ITEM 4.1**DEVELOPMENT APPLICATION – 23036876 – 38 MALCOLM STREET, MILLSWOOD**

DEVELOPMENT NO.:	23036876
APPLICANT:	Karmen & Darryl Wakelin C/- Future Urban
ADDRESS:	38 MALCOLM ST MILLSWOOD SA 5034
NATURE OF DEVELOPMENT:	Construction of a two-storey detached dwelling, front fence, swimming pool with associated safety barriers and demolition of ancillary structures
ZONING INFORMATION:	<p>Zones:</p> <ul style="list-style-type: none"> • Established Neighbourhood <p>Overlays:</p> <ul style="list-style-type: none"> • Airport Building Heights (Regulated) • Building Near Airfields • Historic Area • Prescribed Wells Area • Regulated and Significant Tree • Stormwater Management • Traffic Generating Development • Urban Tree Canopy <p>Technical Numeric Variations (TNVs):</p> <ul style="list-style-type: none"> • Maximum Building Height (Metres) (Maximum building height is 6m) • Minimum Frontage (Minimum frontage for a detached dwelling is 21m) • Minimum Site Area (Minimum site area for a detached dwelling is 1,000 sqm) • Maximum Building Height (Levels) (Maximum building height is 1 level) • Minimum Side Boundary Setback (Minimum side boundary setback is 2m for the first building level; 4m for

Figure 1 Streetscape elevation

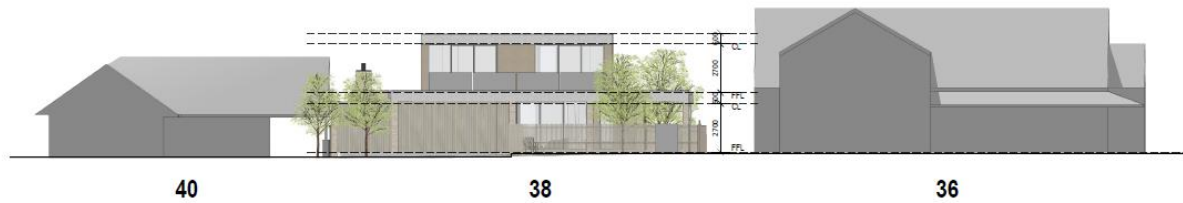
Can you please provide a streetscape elevation to understand how the proposed dwelling will sit within the locality.

A streetscape elevation has been included in the Architectural Drawings in **Appendix 1**, and shown in **Figure 1** below.

As can be seen, the proposed dwelling sits much lower than the dwelling at 36 Malcom Street, and provides a logical and sympathetic transition to the height of the dwelling at 40 Malcom Street, to appropriately blend with the proportions of built form within the streetscape.
